**CITY PLAN COMMISSION****THURSDAY, MARCH 21, 2024****FILE NUMBER:** S234-067**SENIOR PLANNER:** Sharmila Shrestha**LOCATION:** between Easy Street and Jane Lane, at the terminus of Norma Street**DATE FILED:** February 22, 2024**ZONING:** IR**CITY COUNCIL DISTRICT:** 6**SIZE OF REQUEST:** 0.566-acre**APPLICANT/OWNER:** Arleen Macias

**REQUEST:** An application to replat a 0.566-acre tract of land containing all of Lots 1, 11, 12, and 17 in City Block A/6364 to create one lot on property between Easy Street and Jane Lane, at the terminus of Norma Street.

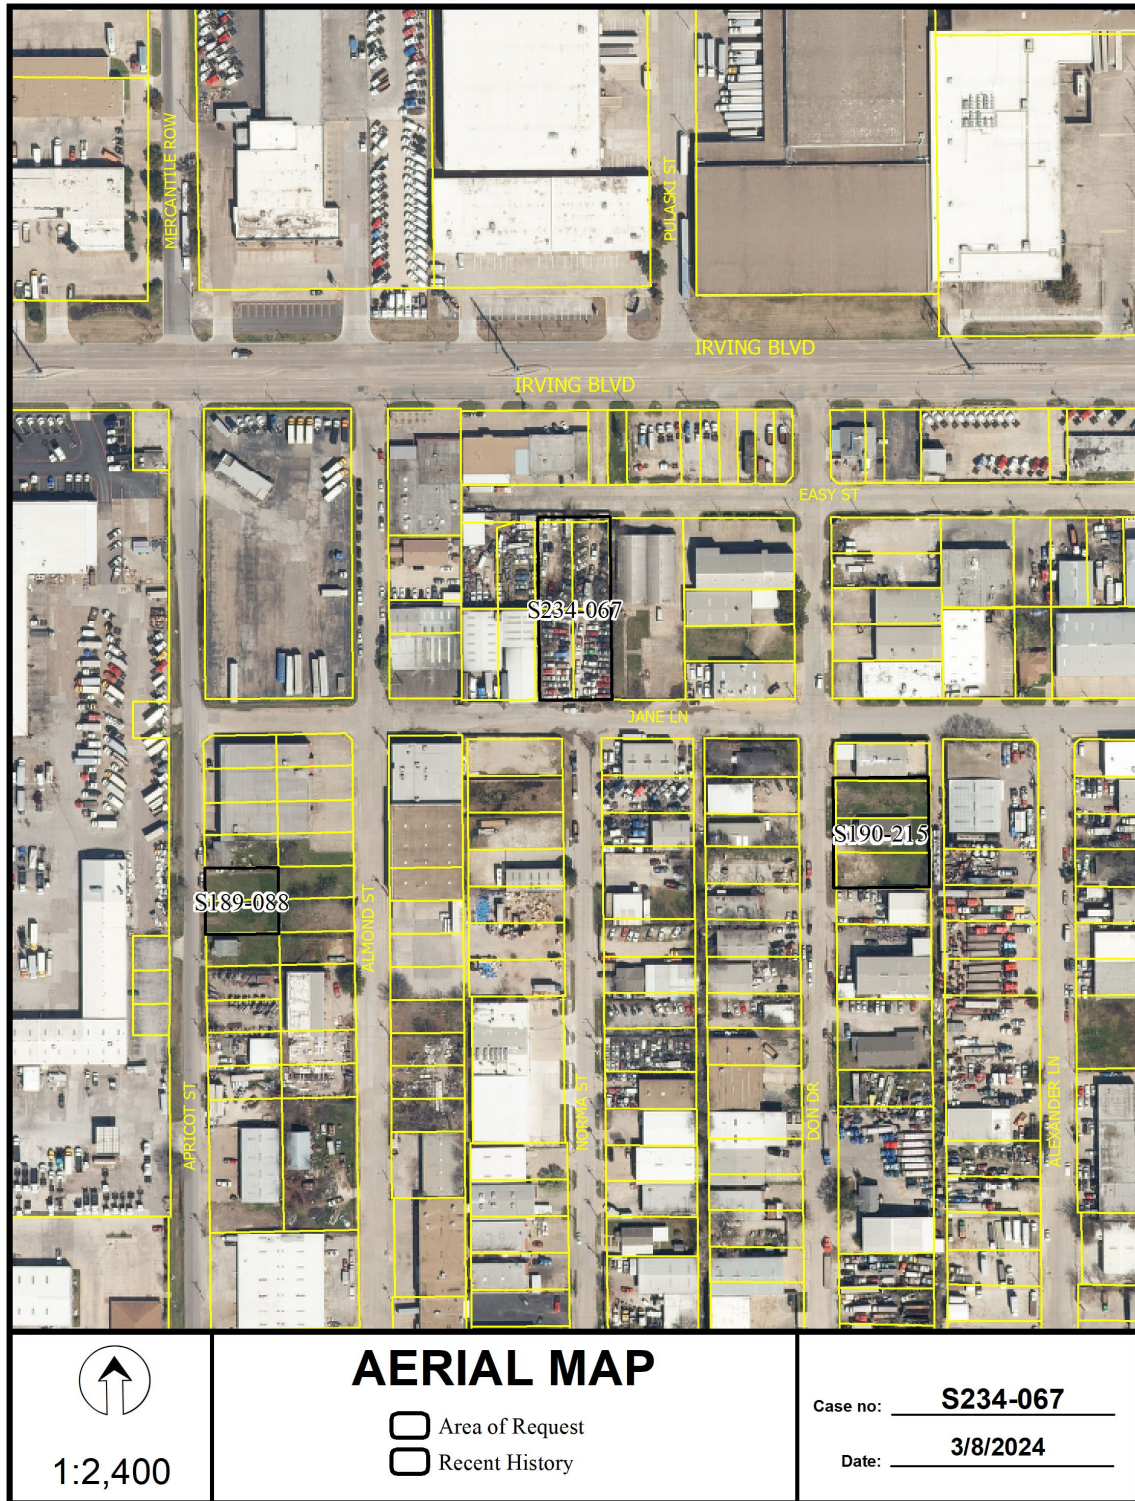
15. On the final plat, dedicate 28 feet of right-of-way (via fee simple or street easement) from the established centerline of Easy Street and Jane Lane. *Sections 51A-8.602(c), 51A-8.604(c) and 51A-8.611(c).*

16. Prior to final plat, submit a completed final plat checklist and all supporting documents.
17. On the final plat, show recording information on all existing easements within 150 feet of the property.
18. On the final plat, show all additions or tracts of land within 150 feet of the property with recording information.

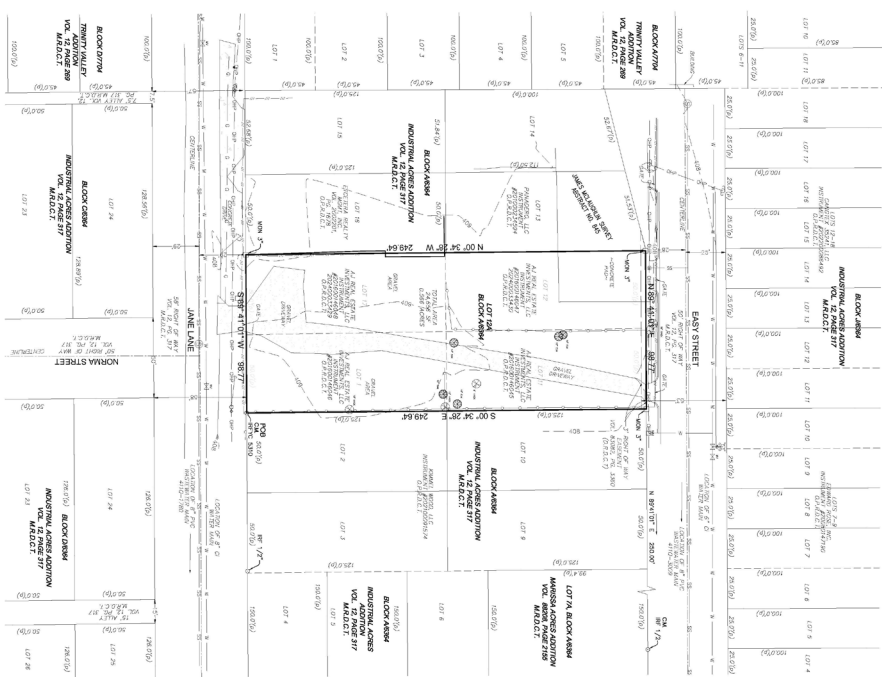
19. Additional design information is required for assessment. Site plan must be submitted showing proposed development, building finished floor elevation, development, existing mains – including downstream manhole, and proposed water and wastewater service locations. Submit water/wastewater engineering plans to 320 E. Jefferson Blvd., Room 200, Attention: Water and Wastewater Engineering.
